Report on Consultation - Route Selection

Project: Abhainn Dubh Wind Farm

Connection

REF: LT000503

Figure 2.2
Route Options

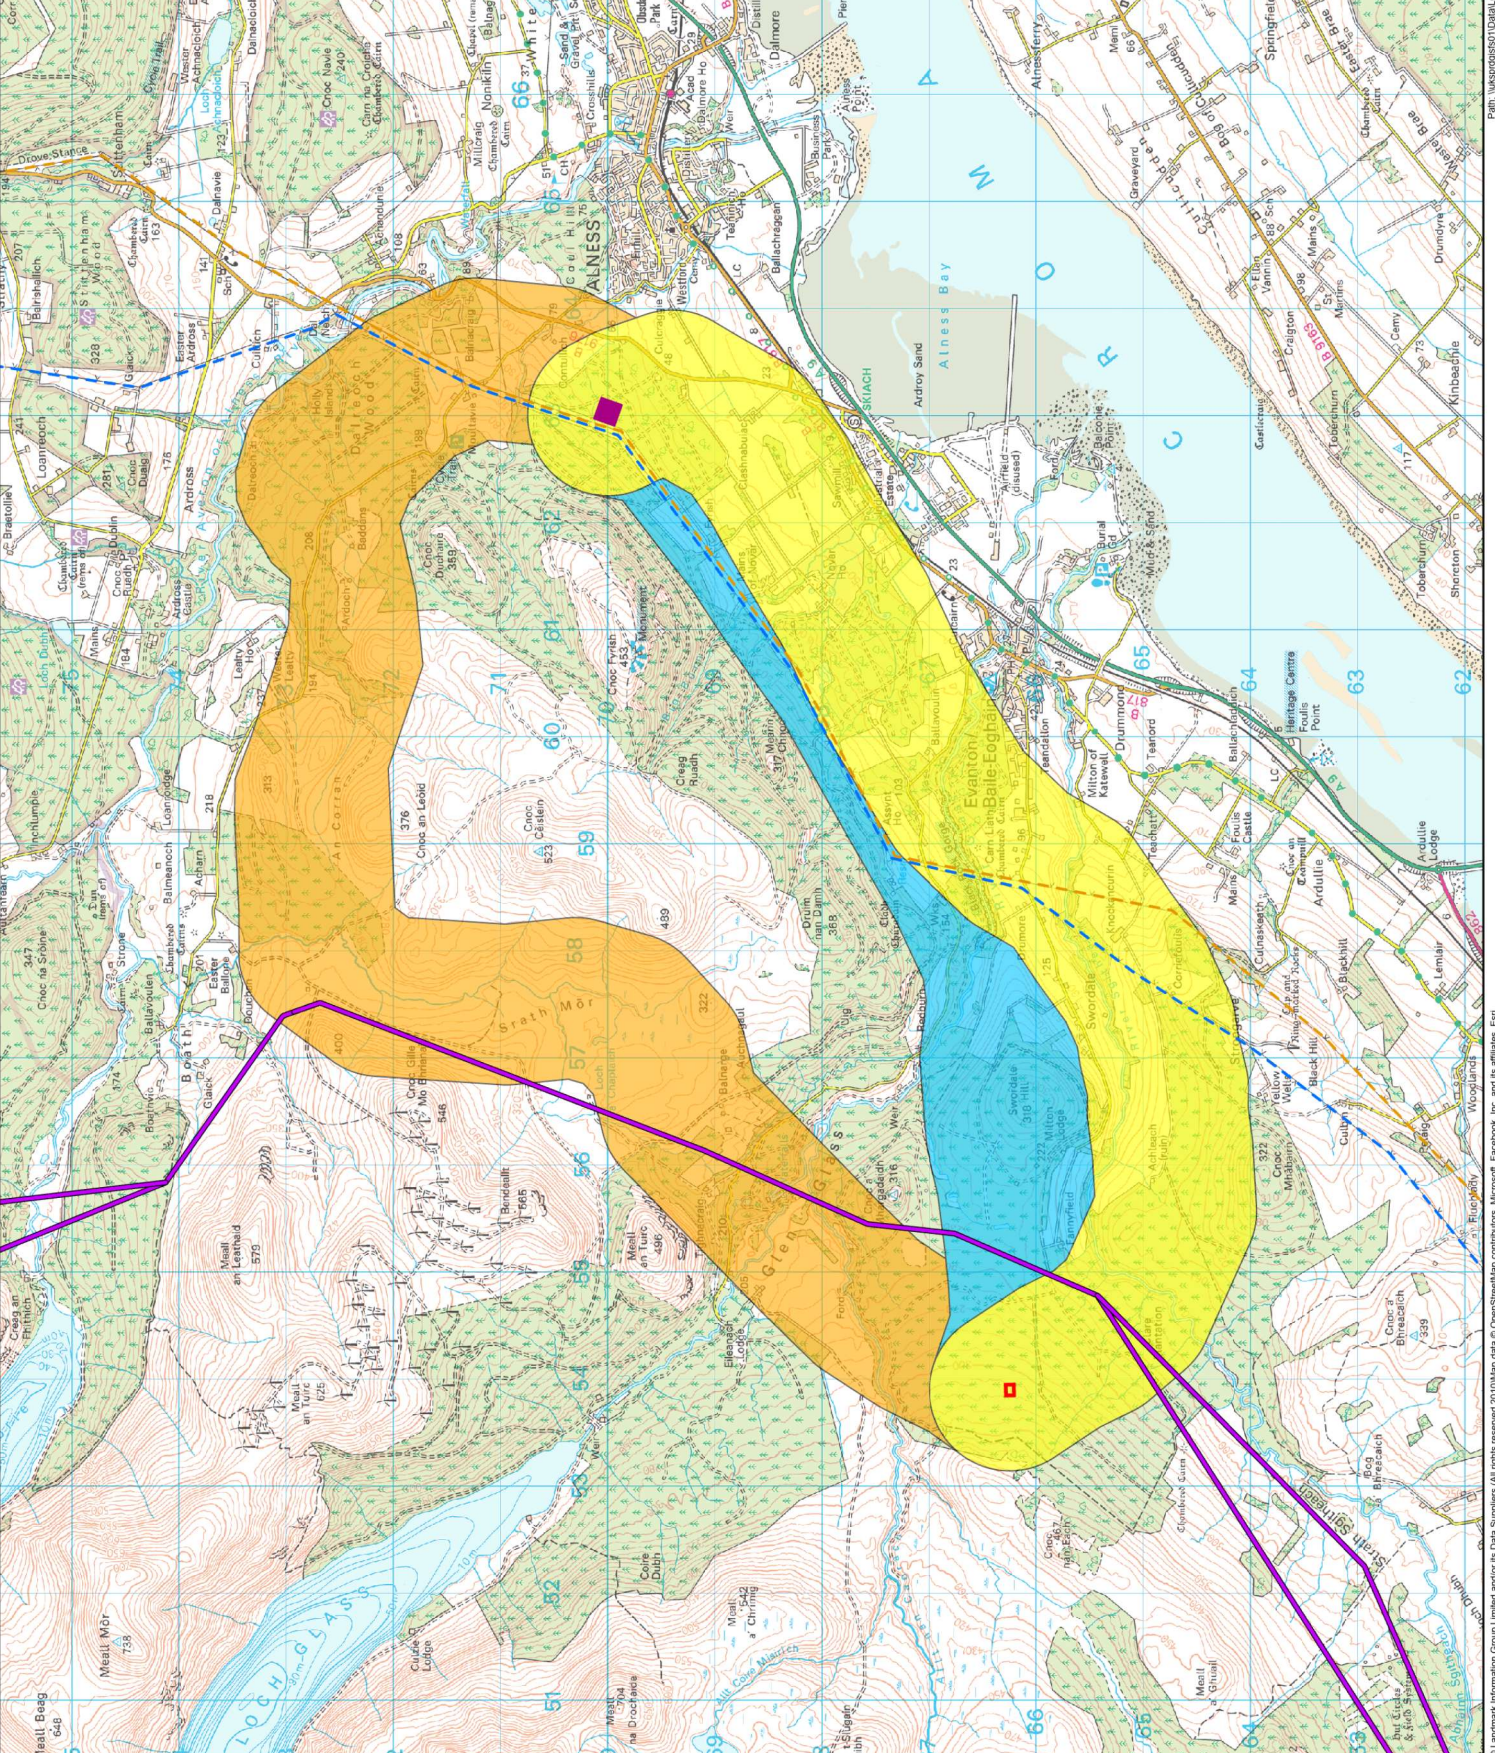
Landowner 2	<p>Preference for orange coloured corridor (Route 1). Concerns regarding the yellow route (Route 3) due to the areas of forestry it would impact.</p> <p>Request to keep updated on the progression.</p>	<p>SSEN Transmission acknowledge the preference of Route Option 1 and the concerns regarding Route Option 3. SSEN Transmission have undertaken RAG Rating as part of the optioneering process which takes into account a number of parameters.</p>
Landowner 3	<p>Recognise the geographical location of the Fyrish substation with respect to industry connections, and will try to facilitate these connections where they are located sympathetically and along a route we can work with. Noted have been a constructive stakeholder in a number of grid connections to nearby substations, and hopes to continue to be so.</p> <p>Particular objection to use of OHL for the proposed connection. Route Option 1 has a significant range of constraints and technical, commercial and legal challenges to overcome, but there is a possibility a route through that corridor could be supported.</p> <p>Route Option 3 is least preferred and considered disastrous. It is very difficult to see a route within Route Option 2 that could be tolerated.</p> <p>Unless project pivots to underground cable and drop Route Options 2 and 3, it is assumed that we will strenuously object to your application. This would be a matter of personal regret, however unable to comprehend the rationale for an OHL coming through low ground.</p>	<p>SSEN Transmission acknowledge the preference of Route Option 1. The Proposed Development has been restricted since commencement, as noted by a lack of Corridor Optioneering Assessment due to a lack of alternative options. Whilst it is regrettable that the landowner is hosting a large proportion of the Route, SSEN are very limited on the Route of infrastructure for this Proposed Development.</p>

Landowner 4	<p>Preference for OHL to be taken in the yellow corridor (Route Option 3). Anything within the blue corridor (Route Option 2) would not be of preference; if it was the case would expect to be undergrounded.</p>	<p>SSEN Transmission acknowledge the preference of Route Option 3. SSEN are very limited on the Route of infrastructure for this Proposed Development, however, alternative infrastructure will be considered.</p>
